PLANNING STATEMENT

79 Avenue Road
St Johns Wood
London
NW8 6JD

JCG25352
Planning Statement
Final
7 May 2021

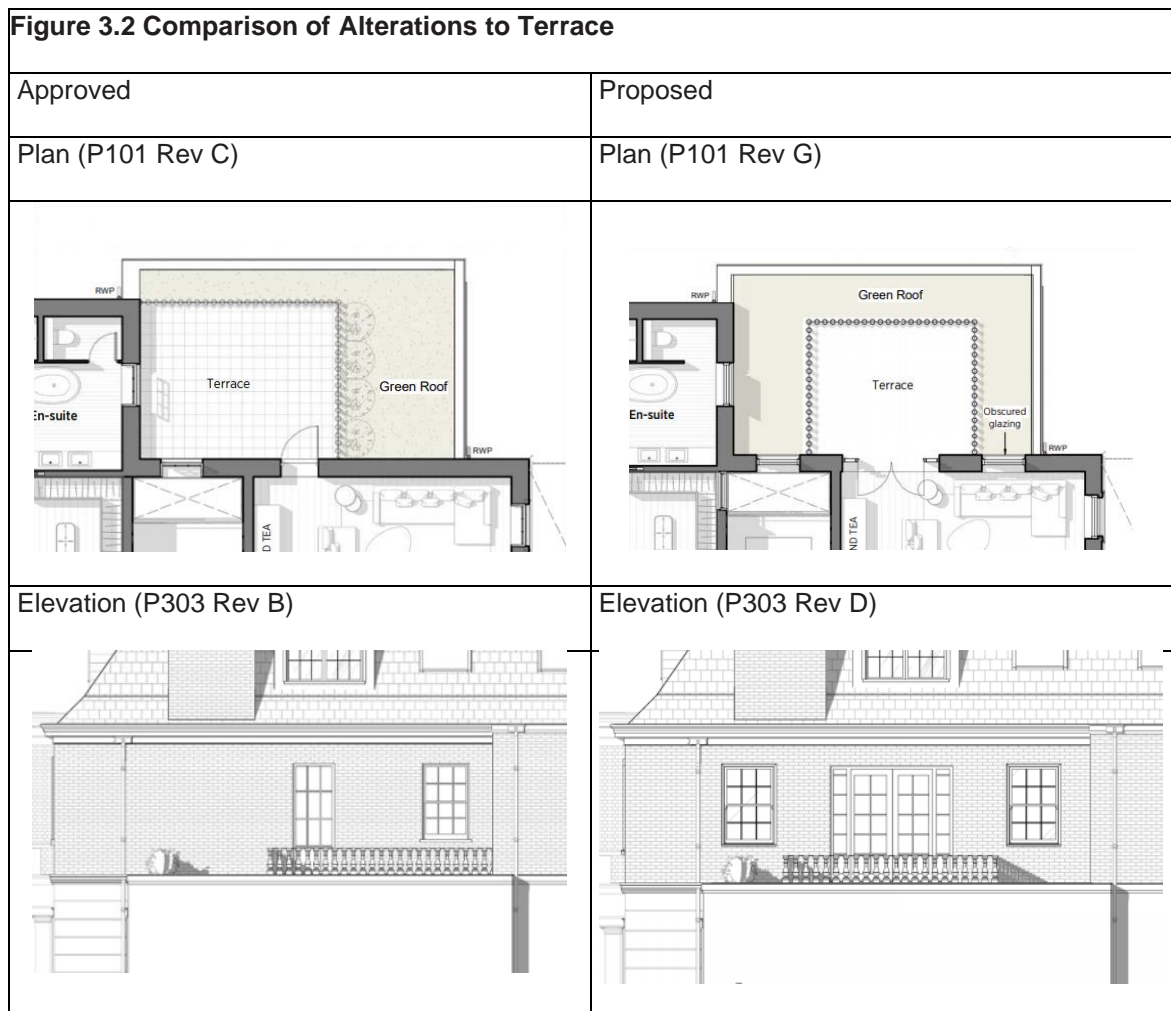
- 3.5 The approved terrace on the north-western elevation sits over the garage and would be accessed at first floor via a single door from the lounge. The terrace is located at the western side of the roof and is overlooked by a single window from the stairwell and a single window from an en-suite bathroom.

- 3.6 It is proposed to move the terrace to a central location on the roof and enlarge the access to a double door. An additional window will also be inserted into the flank elevation wall of the lounge to provide enhanced lighting and and a more balanced fenestration layout. **Figure 3.2** below compares the existing and proposed arrangements.

- 3.7 The proportional split of the garage roof area devoted to terrace and green roof will remain unchanged as will balustrade design and privacy screening for the terrace.

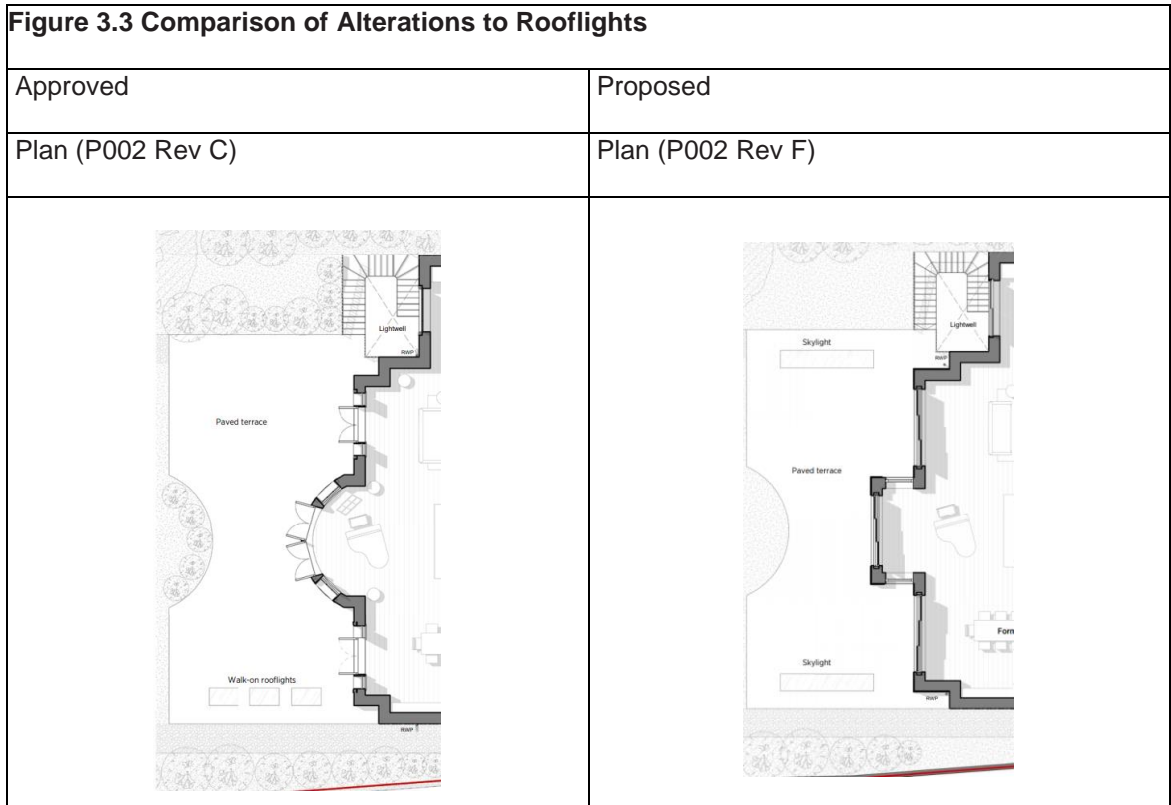
3.9 These changes are situated at the ground floor terrace at the rear of the building and propose both the introduction of a new rooflight to the gym (in the form of a single rectangular form) and the consolidation of the three rooflights to the entertainment room into a single rooflight with the same area (again of a single rectangular form to match that proposed over the gym).

3.10 The approved and proposed plans are shown in Figure 3.3. This proposed alteration has been seen previously by Camden Council.
